FINAL PLAT HENTZEN ADDITION TO SEDGWICK COUNTY, KANSAS

RE: SUB 2002-89 -- One-Step Final Plat of Hentzen Addition

CASE NUMBER: SUB 2002-89 – HENTZEN ADDITION

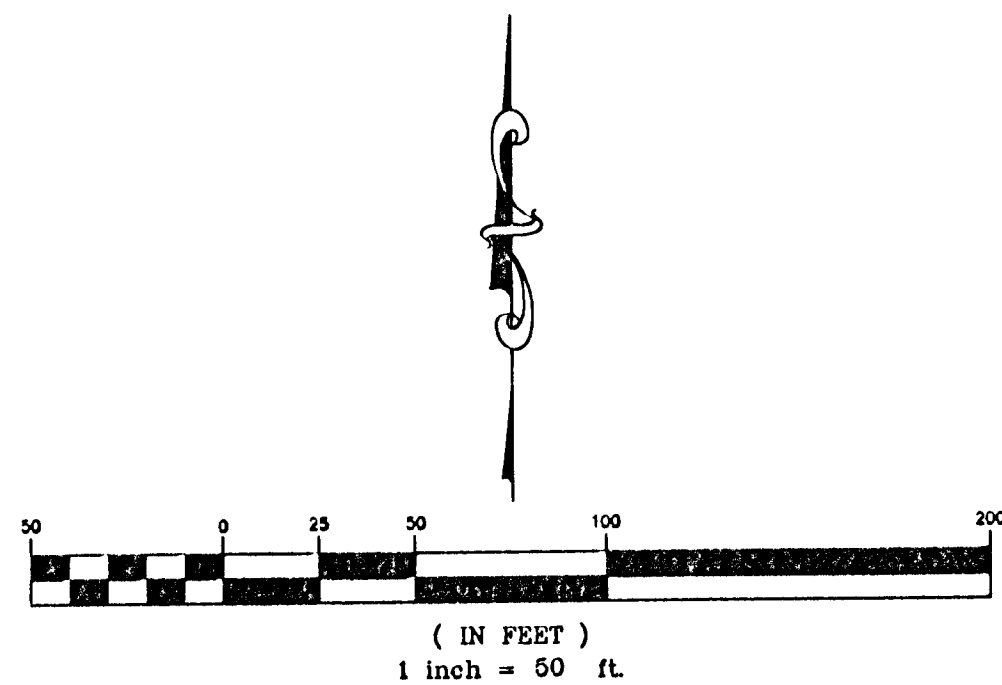
- A. The applicant shall guarantee the extension of sanitary sewer and City water to serve the lots being platted
- B. If improvements are guaranteed by petition, a notarized certificate listing the petitions shall be submitted to the Planning Department for recording.

- C. City Engineering needs to comment on the status of the applicant's drainage plan. The drainage plan is approved. A guarantee is required for drainage improvements.

- D. The plat's text shall include the standard floodway language.
- E. The plat proposes two access openings along both arterials. The openings along 37th St. North are approved. In accordance with the Access Management Policy, the openings along 37th St. North and Hillside closest to the intersection need to be rights-in/out and denoted on the face of the plat. A guarantee is required for construction of a channelized rights-in/out opening. The opening along Hillside located along the south line of the plat is approved as a joint opening with the property to the south, contingent upon closure of the existing opening for the property to the south. In the event, the existing opening for the property to the south is not closed, then this opening should be relocated to be in alignment with the northernmost opening for the property across Hillside. Distances should be shown for all segments of access control. The final plat shall reference the dedication of access controls in the plat's text.

- F. The applicant shall guarantee the closure of the driveway opening located on the abutting property to the south.
- G. A petition is requested for accel and decel lanes, and modification of the traffic signal. A petition is requested for future left turn lanes along both arterials for the openings with full turning movements; which shall not be activated until determination of a need by the Traffic Engineer.

- H. The cross-lot access easement with the property to the south and internal access easements shall be established by separate instrument. Initial construction responsibilities and future maintenance of the driveway within the easement should also be addressed by the text of the instrument.

- I. Traffic Engineering has requested additional right-of-way along both arterials. The Access Management Policy requires a 60-ft half-street right-of-way width along urban arterials. The Policy also requires an additional 25-ft x 25-ft corner clip at the intersection. The Subdivision Committee approved a 50-ft half-street right-of-way.

- J. Provisions shall be made for ownership and maintenance of the proposed reserves. A covenant shall be submitted regarding ownership and maintenance responsibilities.

- M. On the final plat tracing, the MAPC signature block needs to reference "Michael E. Lindebak, Secretary".
- N. On the final plat, the MAPC signature block needs to reference "J.D. Michaelis, Chair".

- O. A signature line needs to be added for the owners.
- P. The Applicant is reminded that a platting binder is required with the final plat. Approval of this plat will be subject to submittal of this binder and any relevant conditions found by such a review.

- Q. The platlor's text shall include language that a drainage plan has been developed for the plat and that all drainage easements, rights-of-way, or reserves shall remain at established grades or as modified with the approval of the applicable City or County Engineer, and unobstructed to allow for the conveyance of stormwater.
